SUBJECT: LANDING GEAR SAFETY SWITCH OVERRIDE

MODELS AFFECTED: M20C 700055 thru 20-1233
 M20E 700035 thru 21-1180
 M20F 700038 thru 22-1441
 M20J 24-0001 thru 24-0237

INTRODUCTION: There have been reports of being unable to retract the landing gear during cold temperature operation of the aircraft. This has been traced to the inability of the landing gear shock biscuits to return fully to size and actuate the landing gear safety (squat) switch. This problem can be alleviated by the installation of a panel mounted by-pass switch.

FIG. 1A

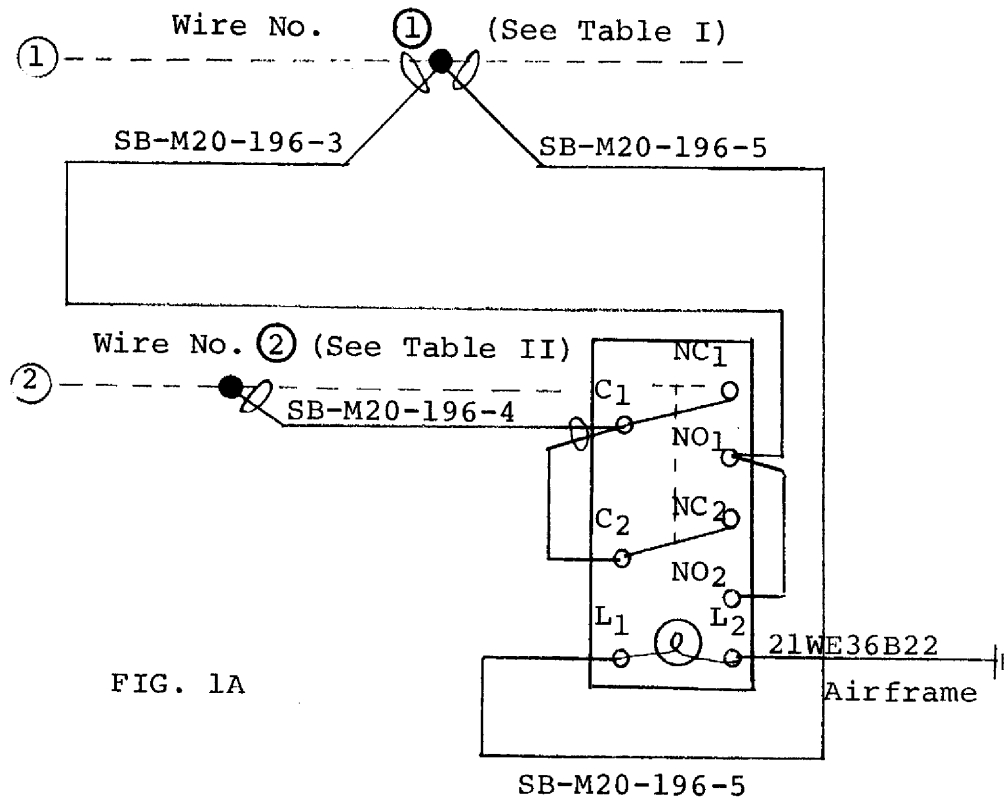
For those aircraft with a single relay system that have not been modified as per Service Instructions M20-34A or M20-34B, the following change needs to be followed:

Wire No. (SB-M20-196-5) and wire no. (SB-M20-196-3) are to be installed together at wire no. ①

FIGURE I

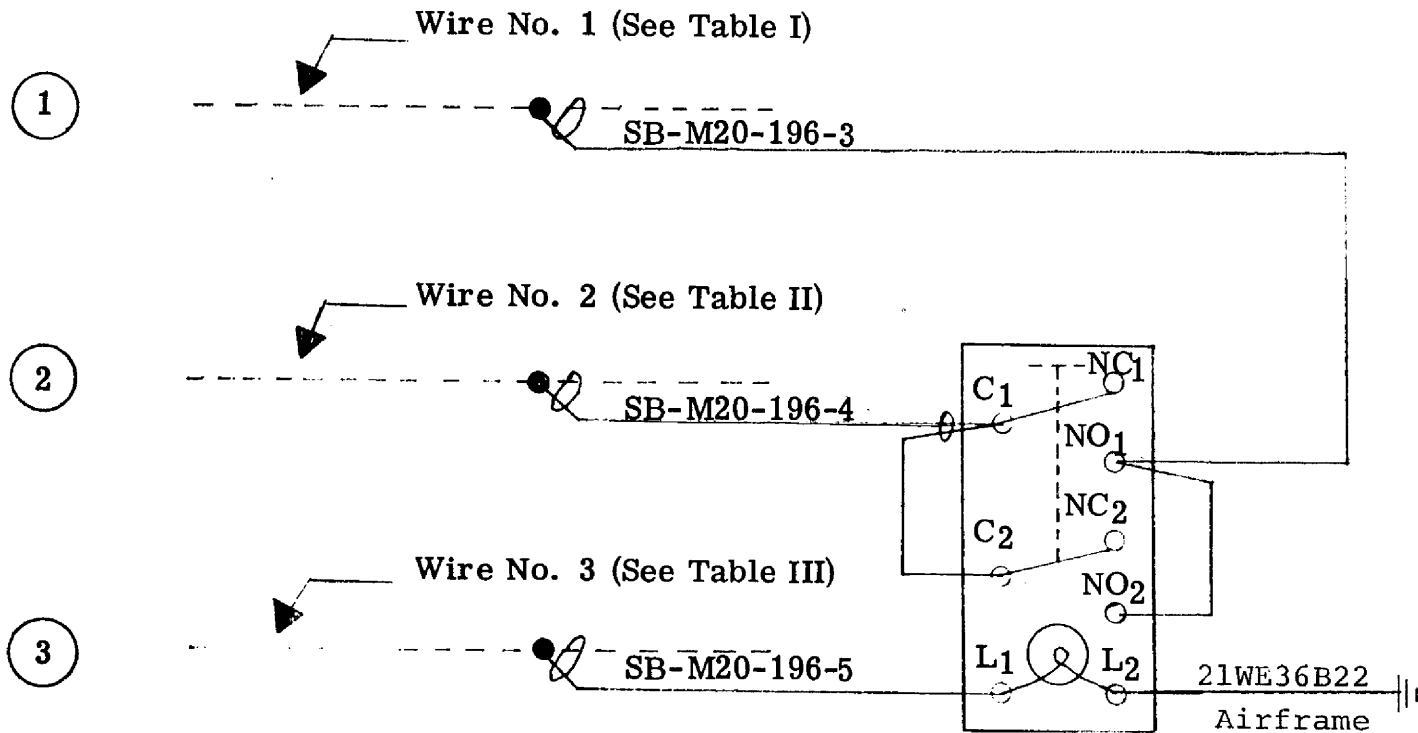
- (4) Locate wire ① (see Table I for wire, plug, and pin numbers for your aircraft). Cut 6 to 12 inches from plug and splice in wire SB-M20-196-3 using window splice supplied. (See Figure I).

- (5) Locate wire ② (see Table II for wire, plug, and pin numbers for your aircraft). Splice in wire SB-M20-196-4 as in step (4). (See Figure 1).
 - (6) Locate wire ③ (see Table III for wire, plug and pin numbers for your aircraft). Splice in wire SB-M20-196-5 as in step (4). (See Figure 1).

FIGURE II

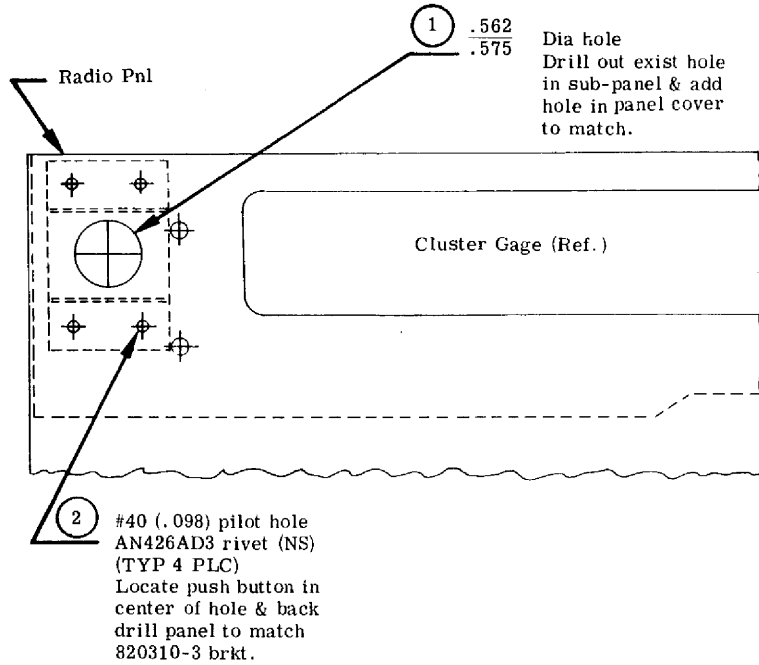
- (3) Install by-pass switch assembly in panel per Figures II thru V. Connect ground wire #21WE36B22 to airframe ground. (Select figure applicable to your serial number aircraft.) Route and secure wires SB-M20-196-3, SB-M20-196-4, and SB-M20-196-5 with existing wire bundle forward to firewall and down to left wing plug.
